ATTACHMENT A

Revise the Technical Specification pages as follows:

## ATTACHMENT B

**FIGURE 1 - LOW PRESSURE INJECTION FLOW**

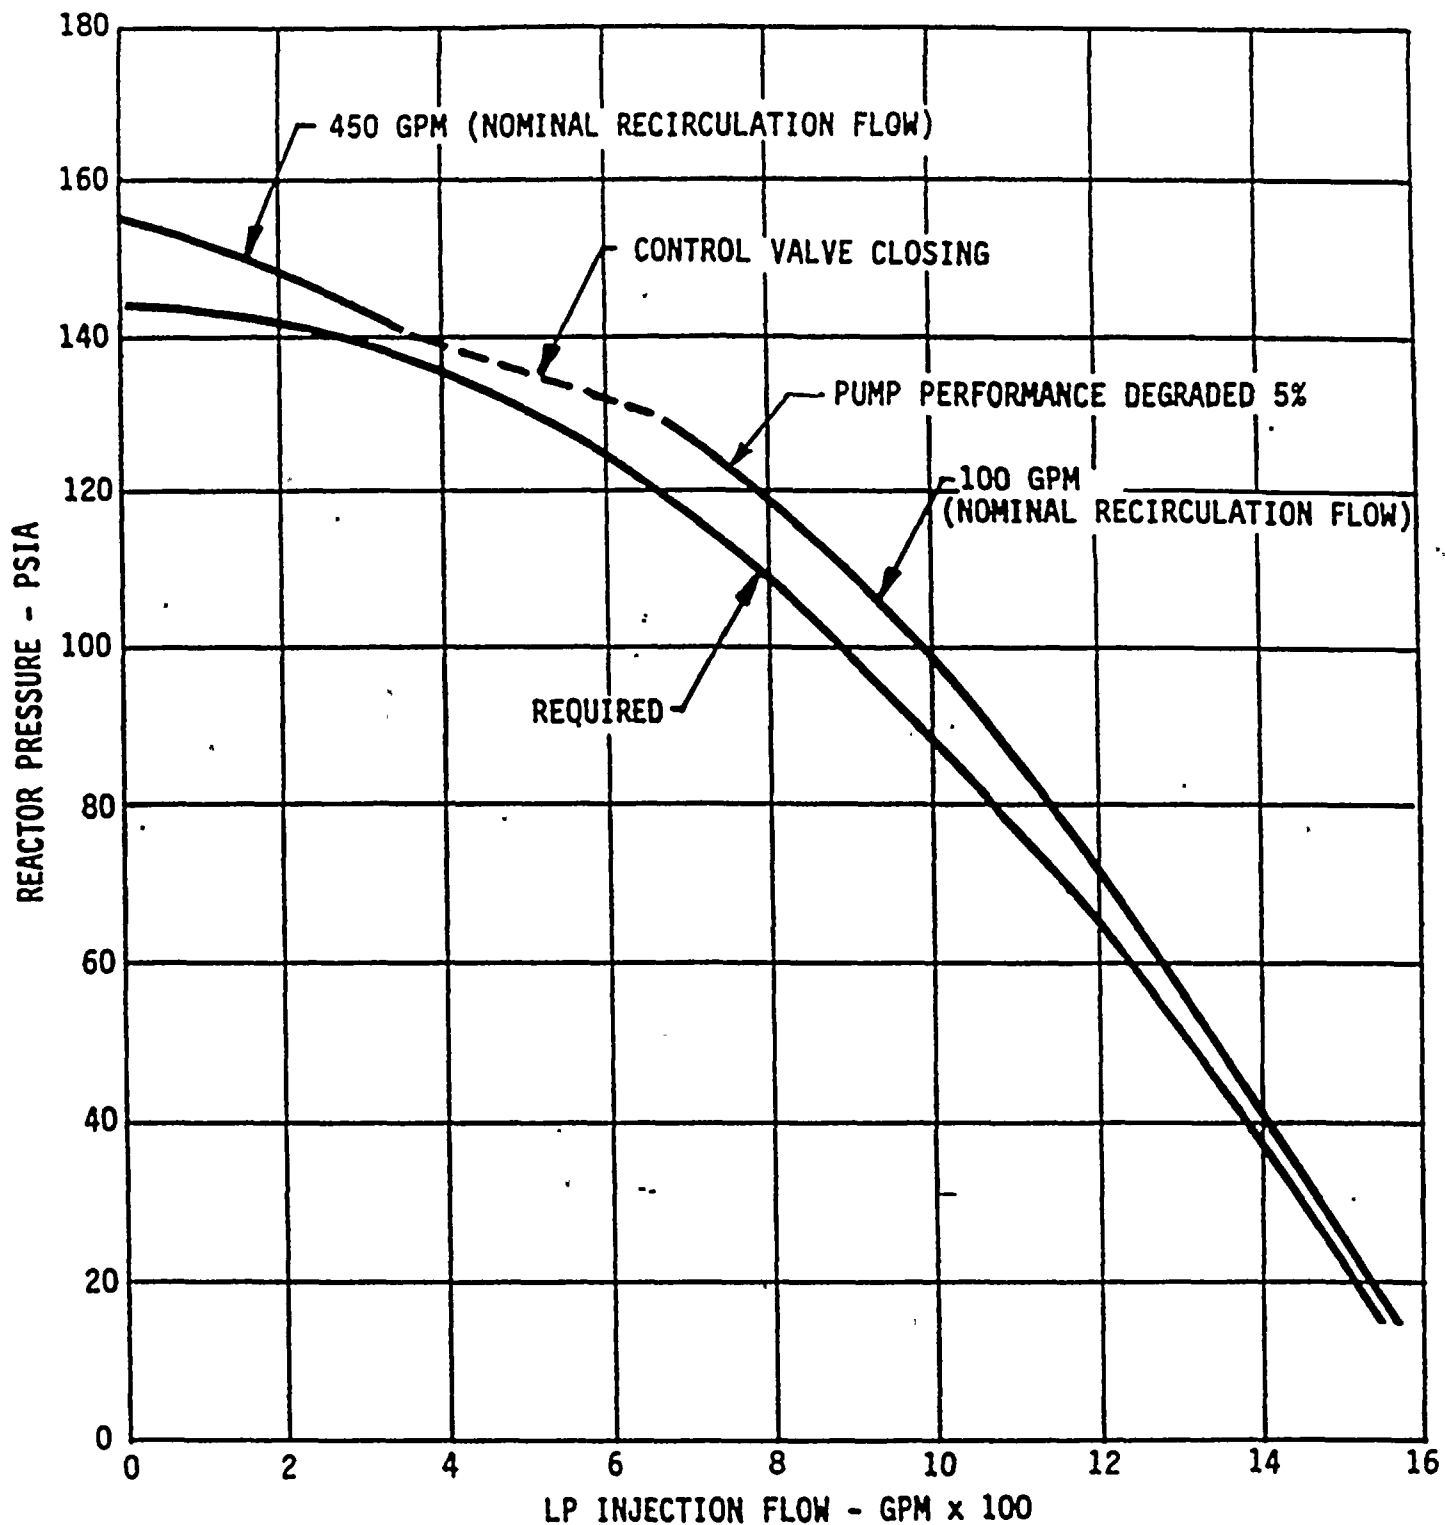
Hydraulic analyses have been performed confirming that discharge pressure values at or above the proposed limits will meet the requirements for system delivery under accident conditions as established by Figures 15.6-12 and 15.6-13 in the UFSAR. These analyses utilized the KYPIPE computer code developed by NUS Corporation for the emergency core cooling system for R.E. Ginna. This code has been validated in accordance with the approved Quality Assurance Program. The results of the analyses relating system delivery versus RCS pressure are shown plotted on the attached Figures 1 and 2. The curves show that required system delivery is achieved assuming the 5% degraded RHR pump performance curve (Figure 1) and the 3% degraded SI pump performance curve (Figure 2). The curves depicted represent the most conservative cases in terms of parameters utilized which limit the flow delivered to the RCS.

1. RHR PUMP "B" VIA MOV852B INJECTION PATH.
2. RHR PUMP PERFORMANCE DEGRADED 5%.
3. RHR PUMP SUCTION HEAD = 15% RWST LEVEL.
4. REQUIRED FLOW BASED ON UFSAR FIGURE 15.6-13.
